Scope of Work – Arctic Bay Sewage Lagoon

The following is meant to describe, in as best of detail as time would permit (1 hour preparation time), the scope of works to be undertaken in the urgent repairs to the Arctic Bay Sewage Lagoon system.

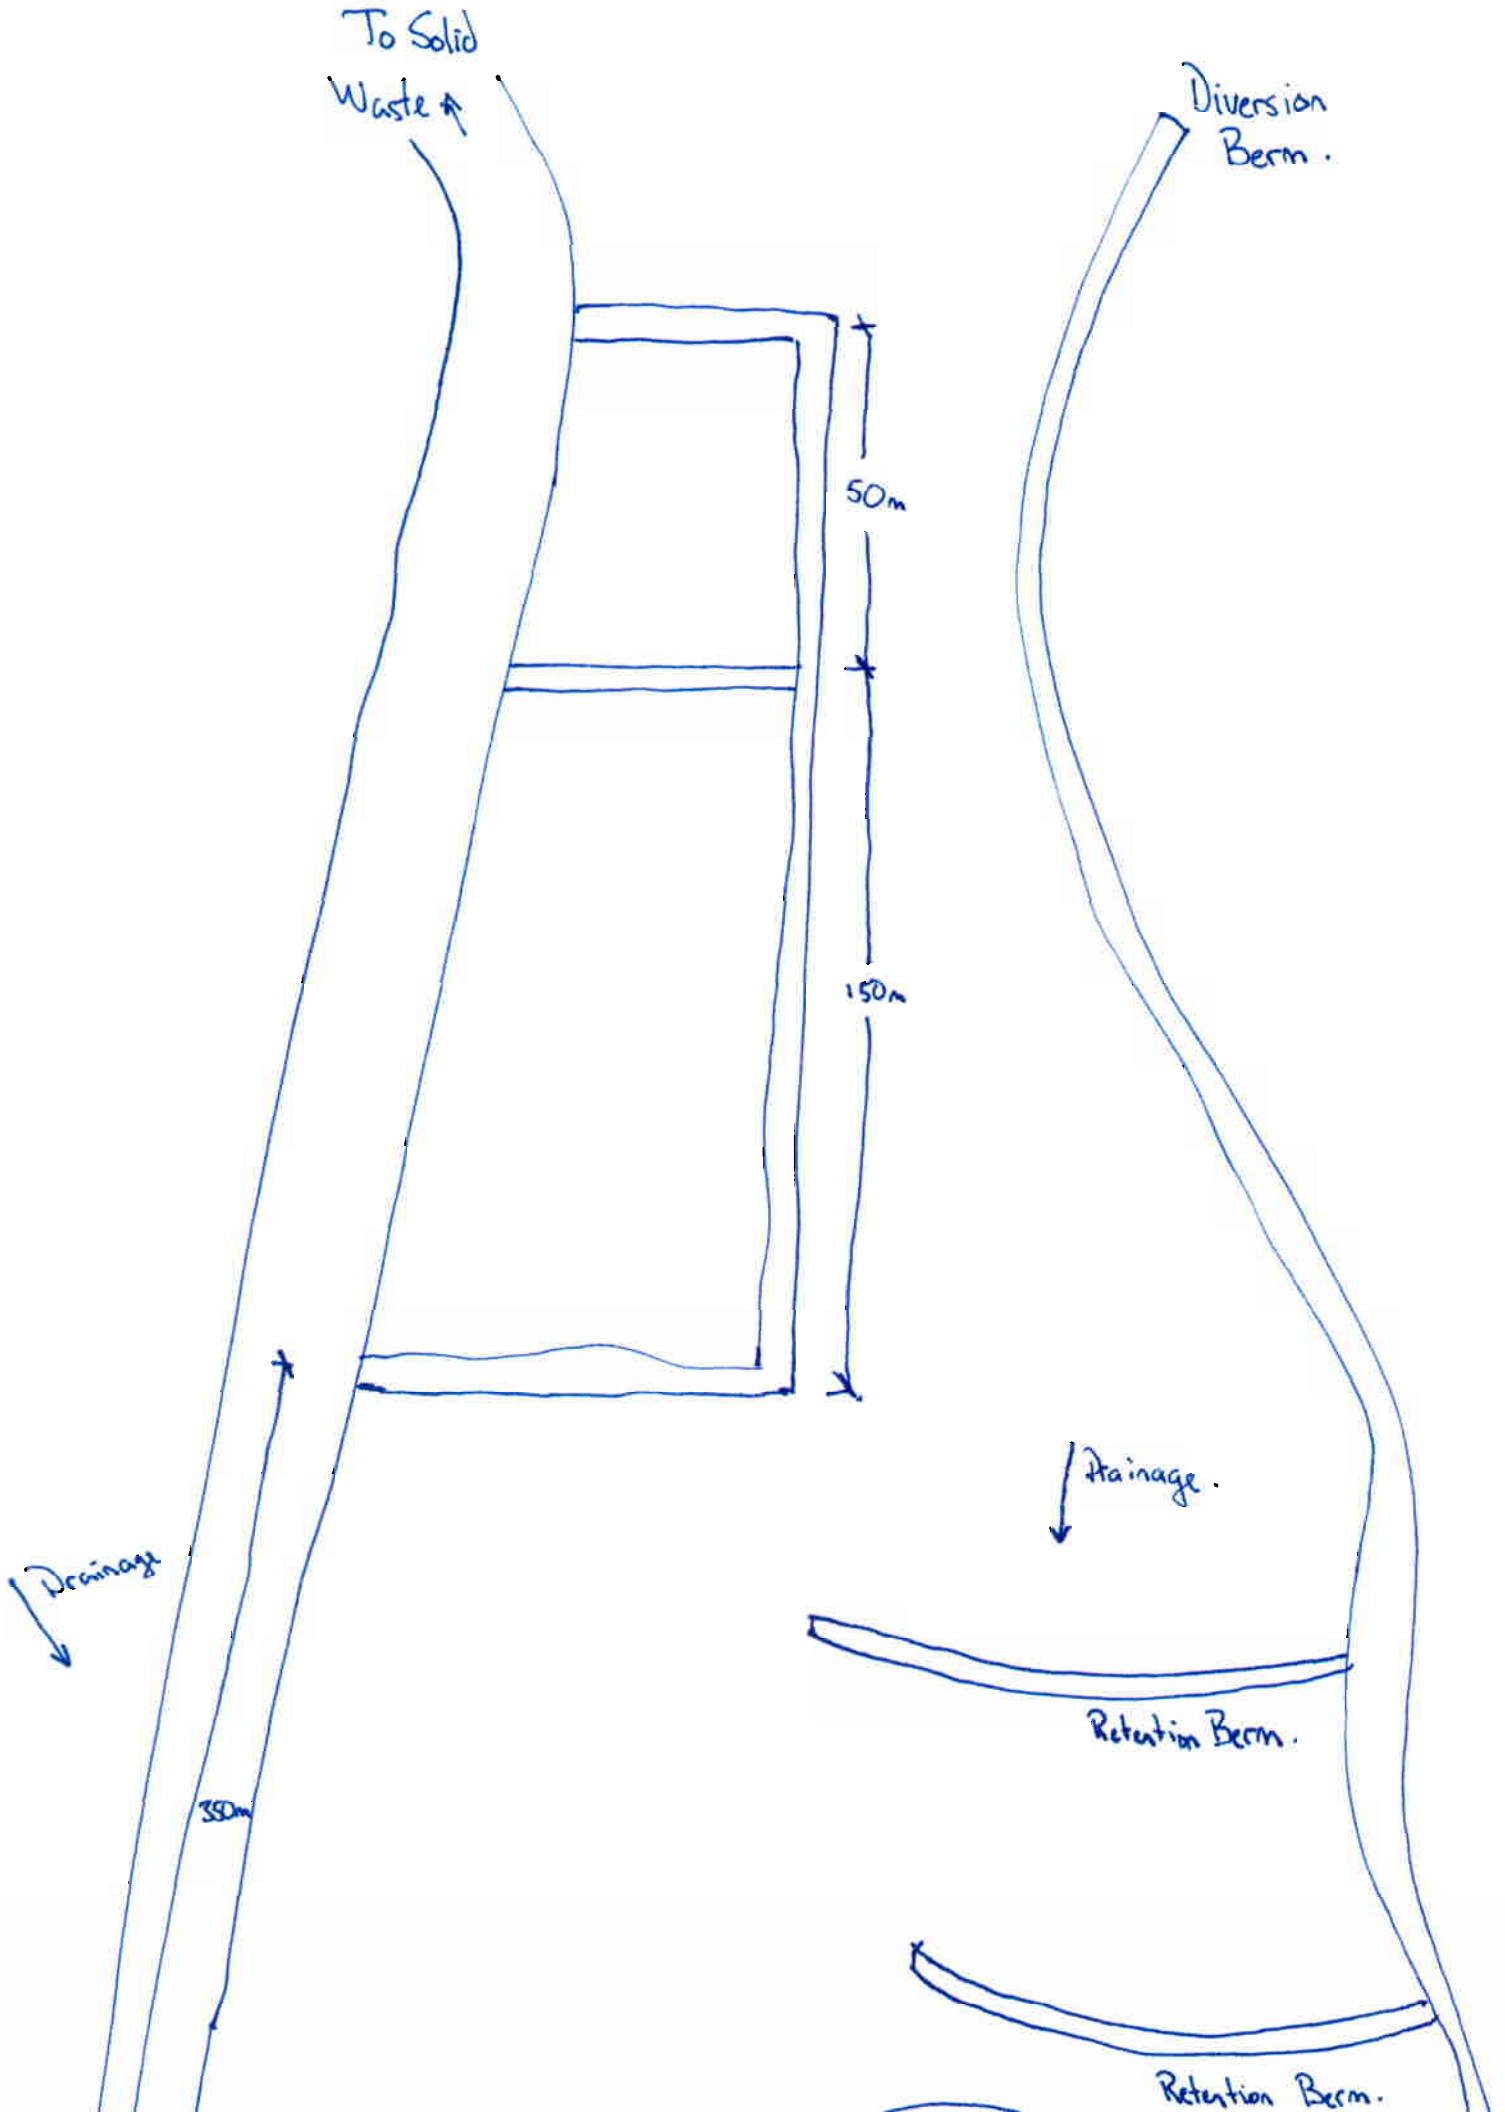
1. Reinforce/Expand South Berm of Winter Storage Cell

The berm of the winter storage cell shall be built up such that the top of the berm has a 3.0 m width (ie sufficient for a pick-up truck to travel on top of). The height of the berm shall remain as is currently build. The slope of the berm shall be the natural slope, approximately 2:1. The berm width shall be expanded from the southwest corner to the first discharge point.

2. Construct Temporary “Access Road” for Construction of Retention Berm

A temporary access road shall be constructed whose purpose shall be to limit damage to the wetland during the construction of a 3rd retention berm. The road may be constructed of whatever material the contractor sees fit and shall be removed as best as possible after construction has been completed.

3. Construct Retention Berm

A third retention berm shall be constructed similar to the existing two retention berms. The location and size shall be field determined and staked out by the Hamlet.

After Step 8, the winter lagoon should look like.

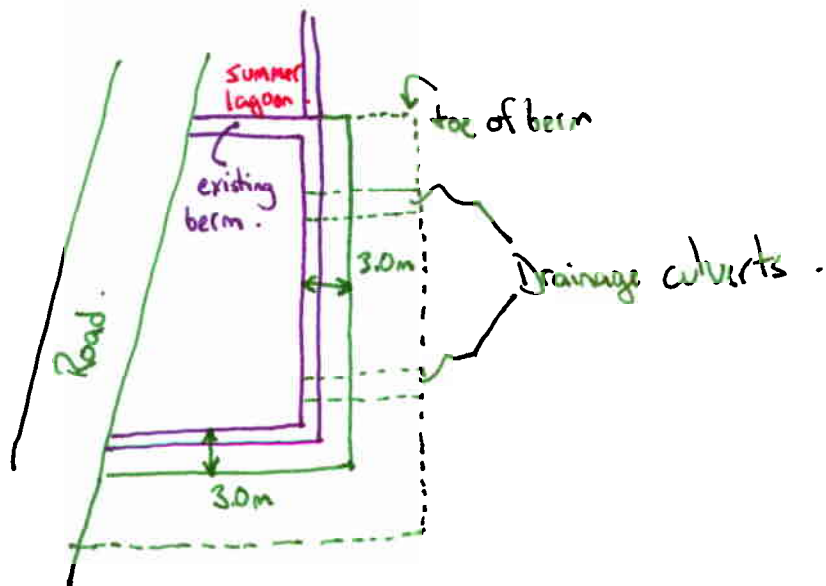
Addendum 1 - Step 8.

- ① At the northern most outflow of winter storage lagoon, construct gravel pad and rip-rap, add culvert, reduce height of berm at this location to encourage drainage from winter lagoon.
- ② ~~If~~ Add "gate valves" to culverts manually controlled from top of berm so as to be able to stop flow through culvert as required.
- ③ Continue building up full length of berm so that top of berm entire length of winter storage lagoon is 3 m width.

Addendum 1- Step 9.

On top of new 3.0 m wide berm, in 100 mm lifts, compacted, increase height of berm by 300 mm
